AGENDA PORTLAND PLANNING BOARD MEETING

Memorandum
Planning and Urban Development Department
Planning Division

To: Sean Dundon, Chair and Members of the Portland Planning Board
From: Shukria Wiar, Planner
Date: May 22, 2020
Re: 126 and 128R North Street, Upright Properties, LLC and Josh Wojcik
Project #: PL-000791-2019 CBL: 012 H009 and 012 H014
Meeting Date: May 26, 2020

A-1.6	
Scale	1/4" = 1'-0"

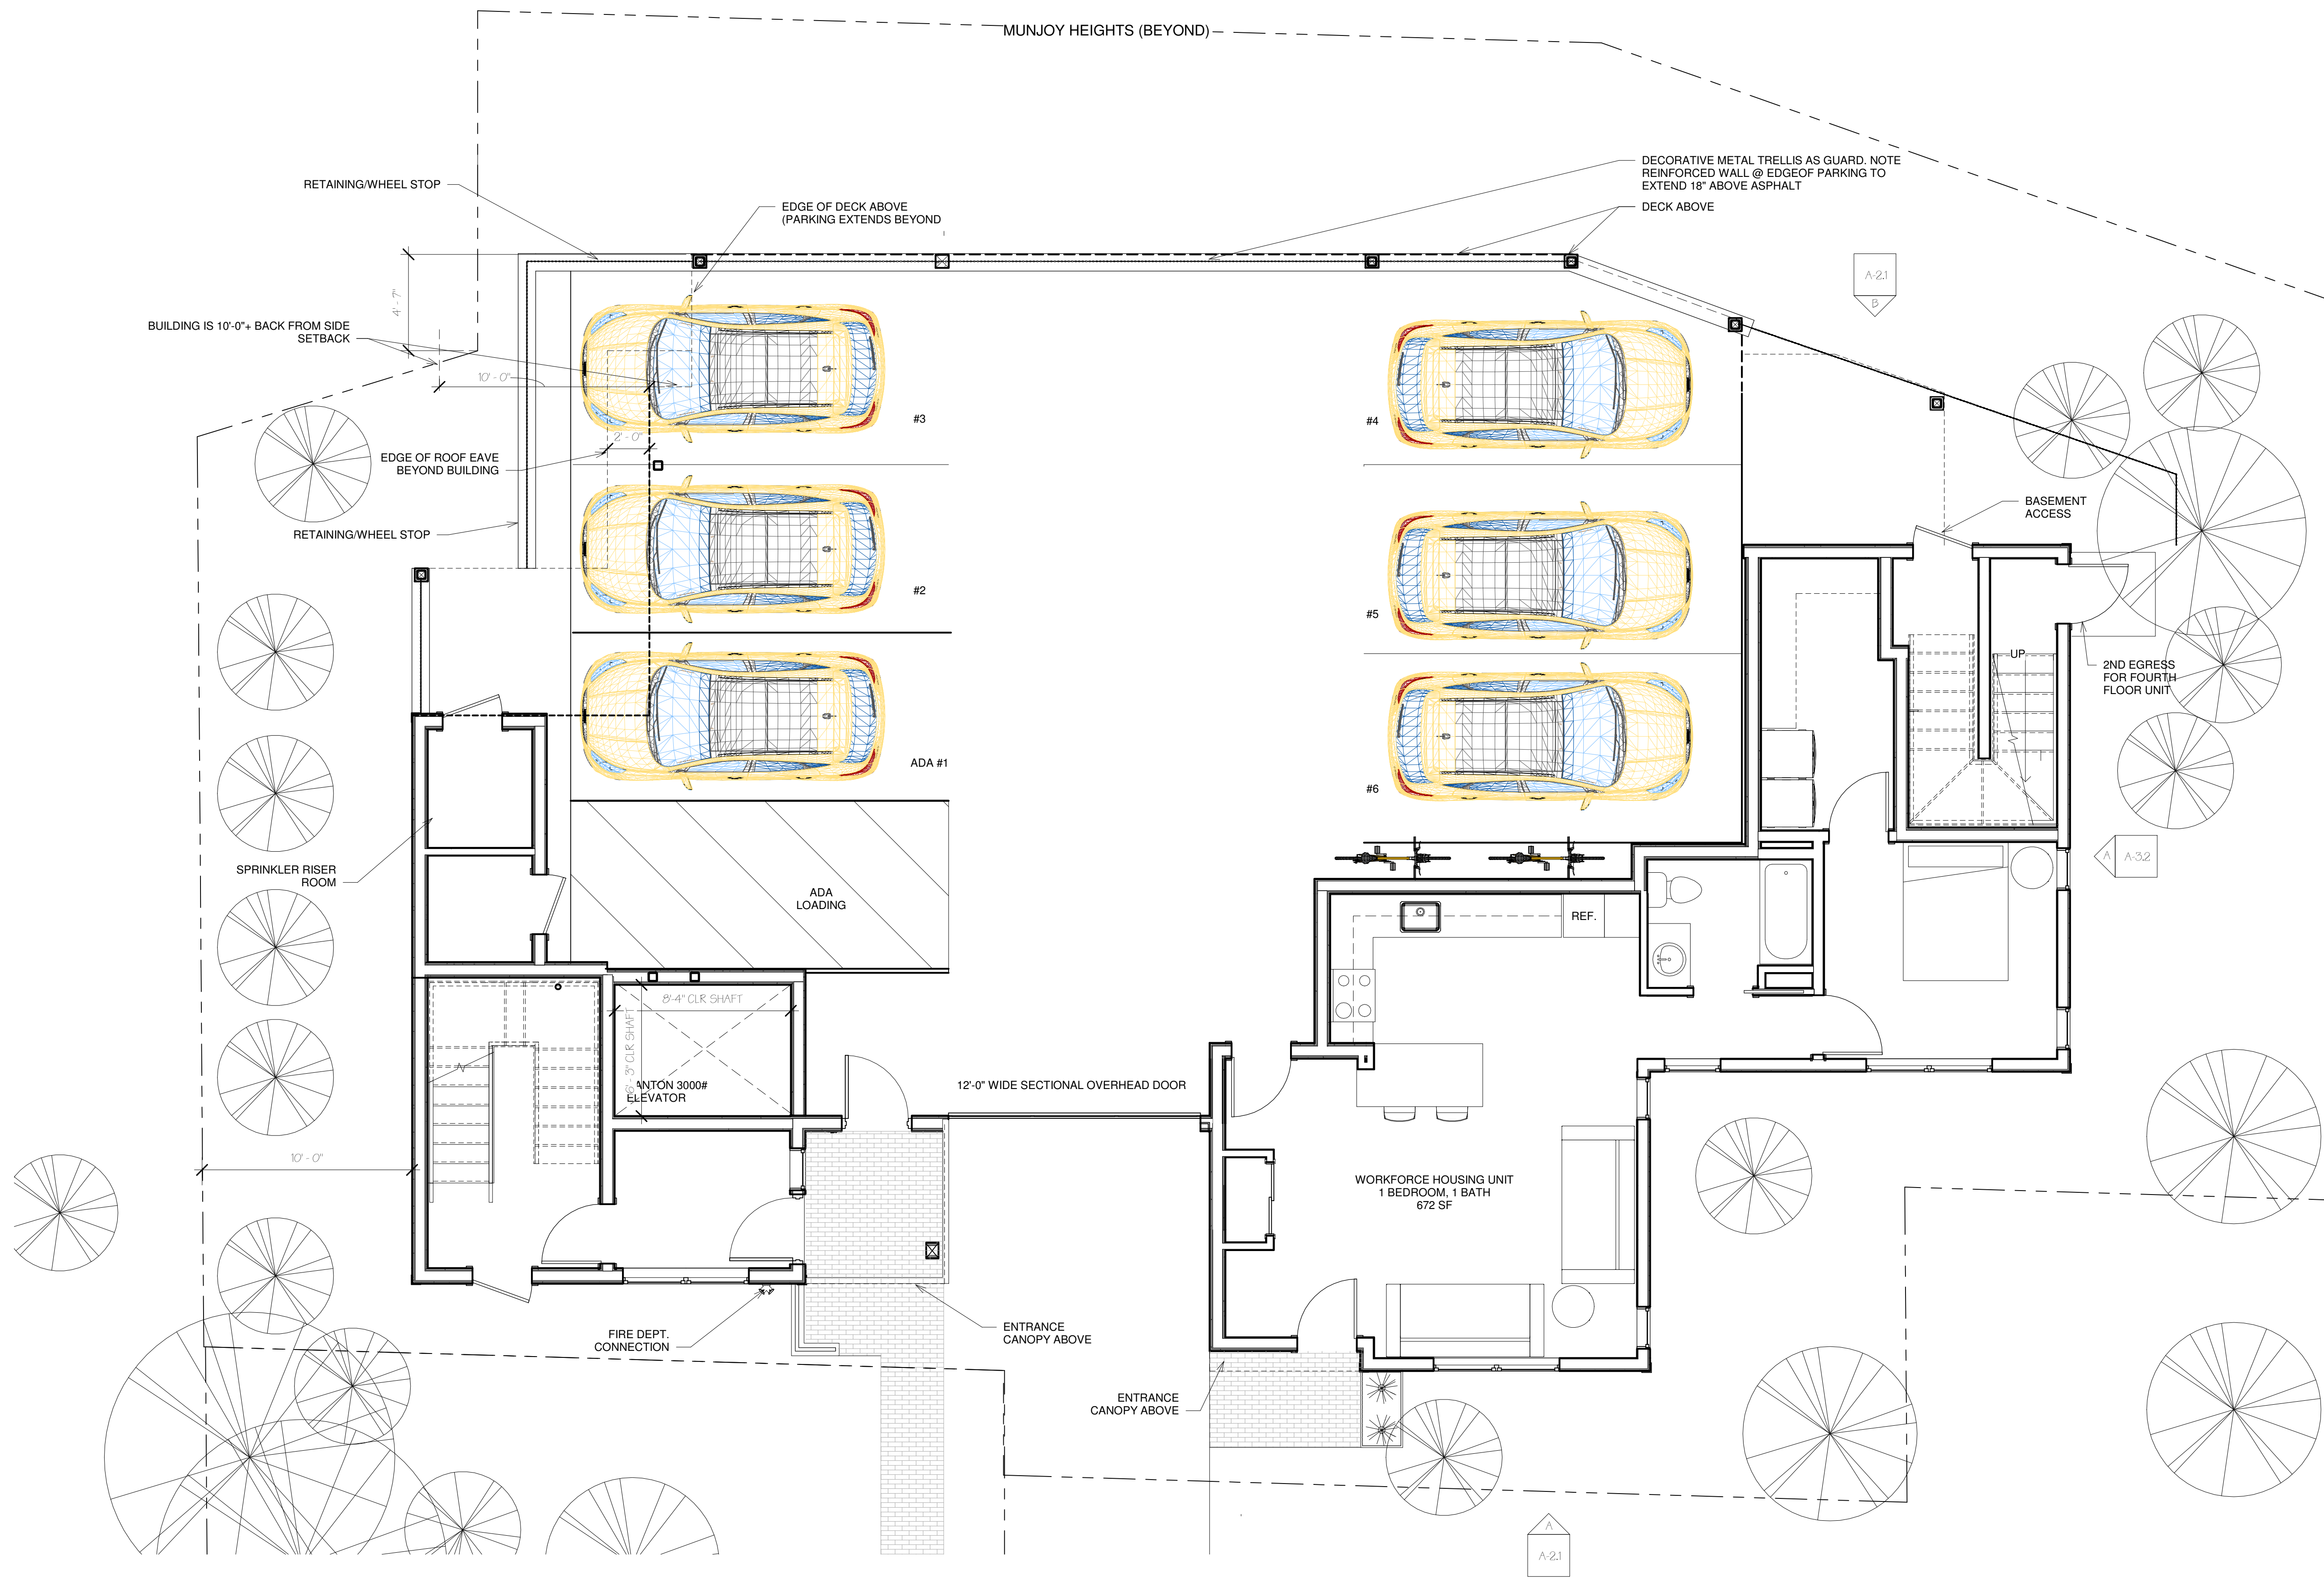
- On sheet A-1.6 you will note that we have added another housing unit, bringing the total for 126 North to six units. The new two-bedroom rear unit allows us to help alleviate Portland's housing crisis and better-meet section 14-487. As a result of the new front hall and access aisle the front unit on the building's first floor will become a one-bedroom unit.

SITE SECTION NORTH STREET TO
WASHINGTON AVENUE
1" = 20'-0"

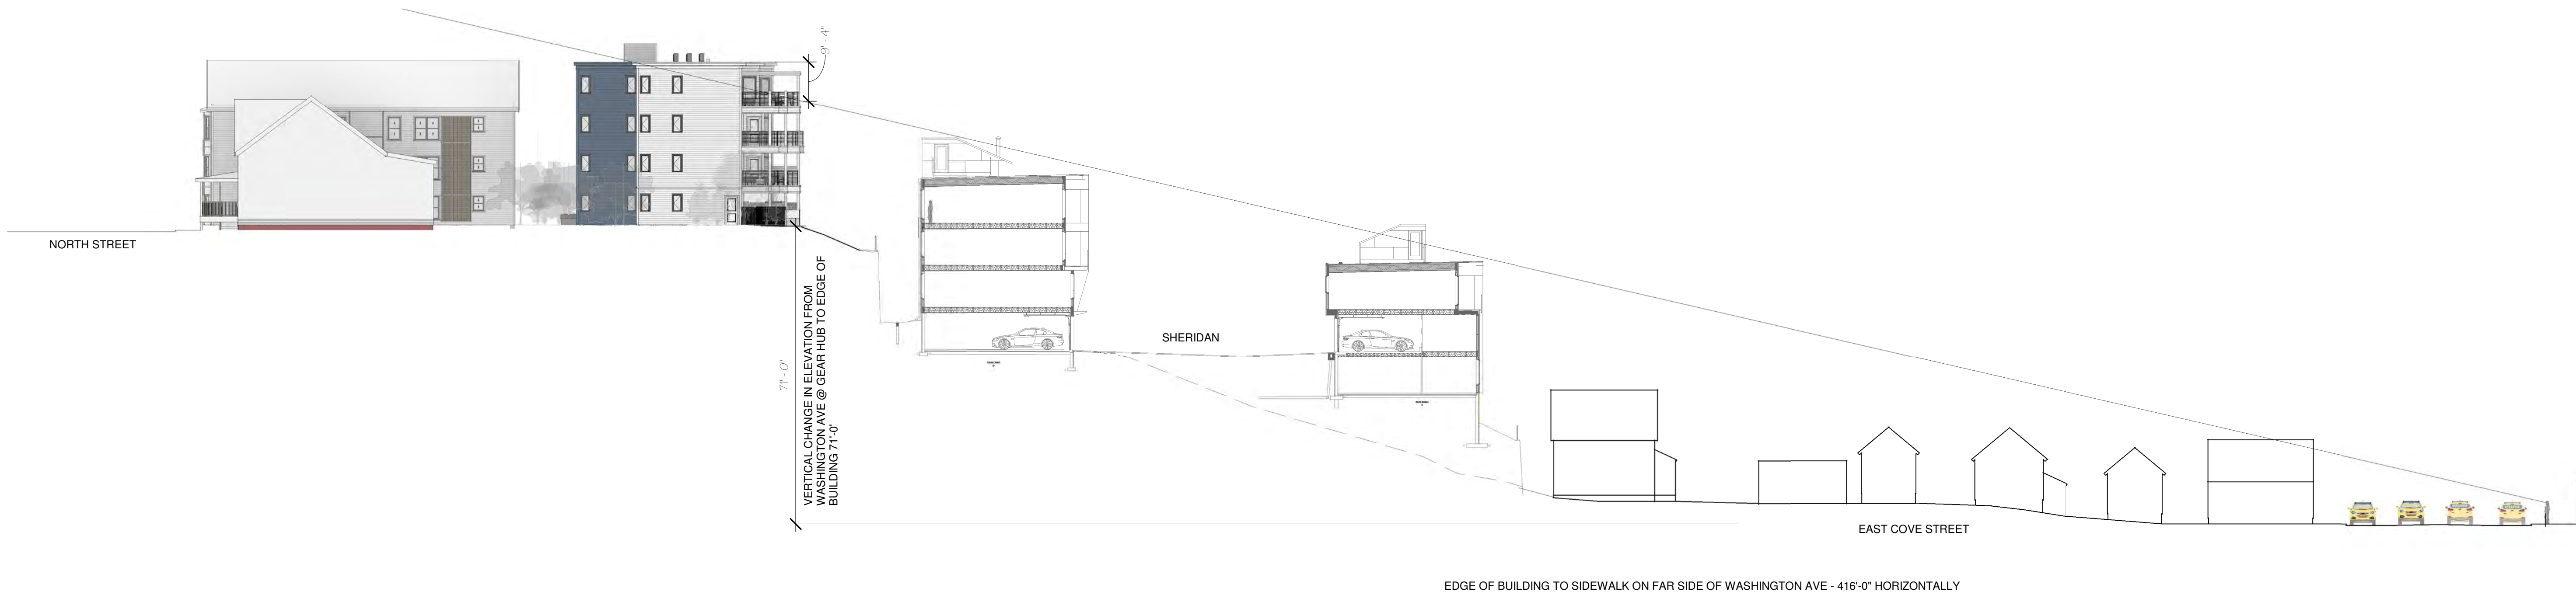
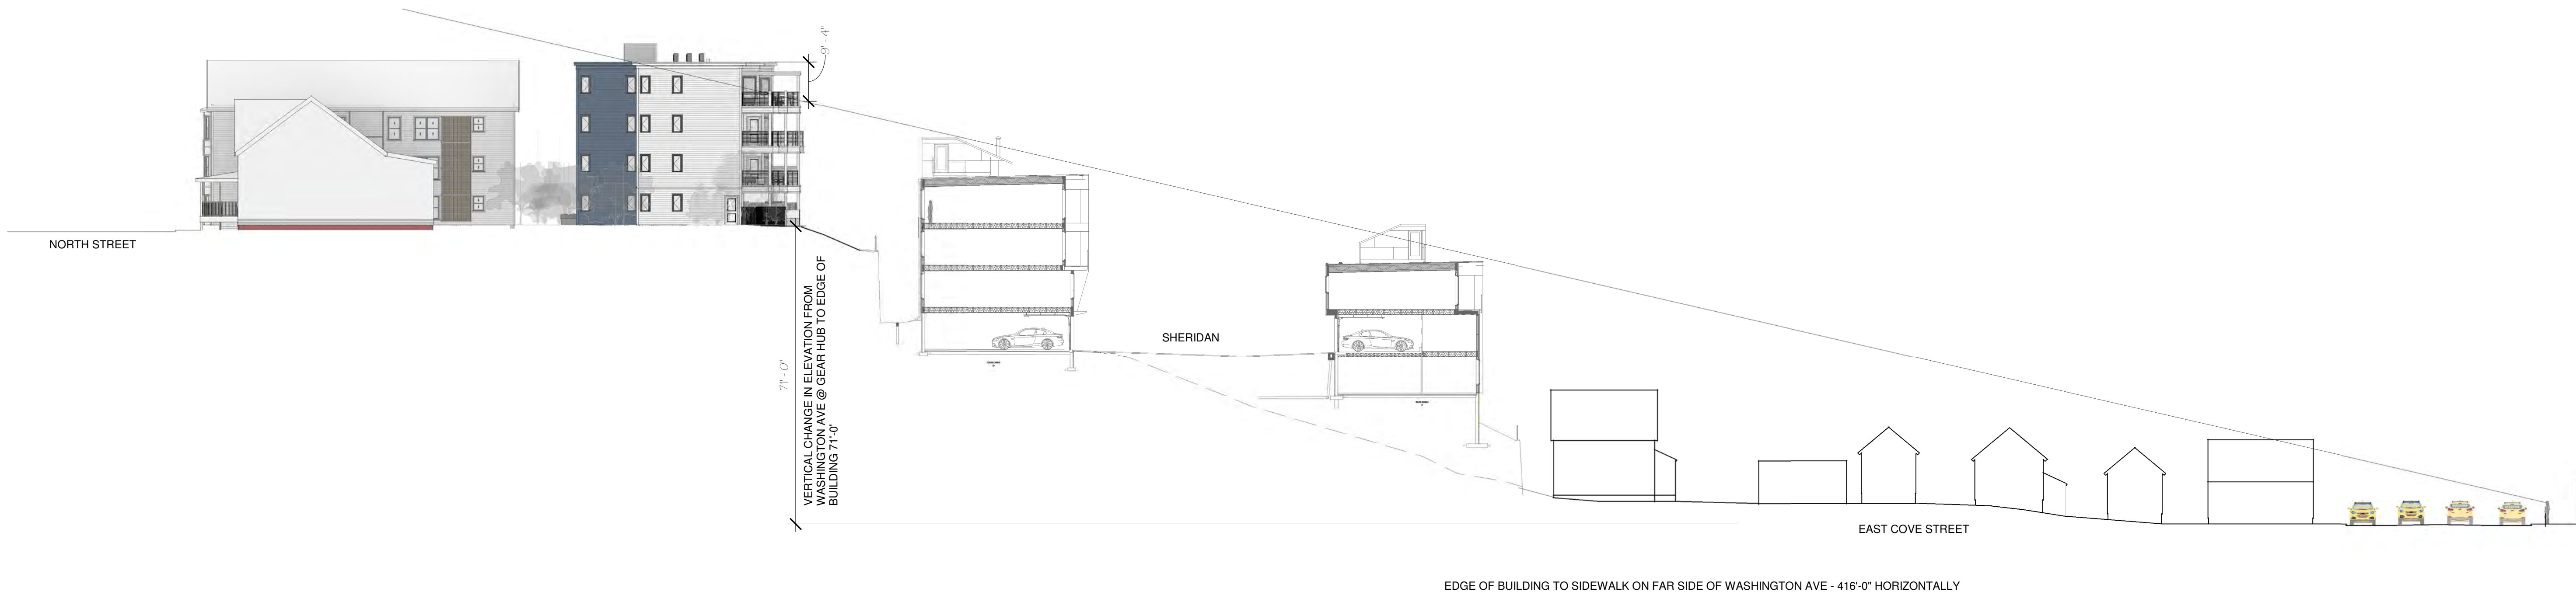
- Also included in our packet is a new sheet, A-3.2 Site Section. As requested by the board, this section spans approximately 610'-0" in length from North Street to Washington Avenue. The site section was developed with spot elevations along Washington Avenue taken from ongoing construction projects, our site survey, Portland's GIS system, the Assessor's database (which provides rough widths of building's), and Google Street view. The section is cut facing the back of buildings at East Cove Street. Our project features many of the same design professionals as the Munjoy Heights project along Sheridan Street, who provided a site section of their project. Based on the spot elevations along Washington Avenue and the elevation of our site, taken from our survey, the building is minimally visible when viewed at the far sidewalk of Washington Avenue.
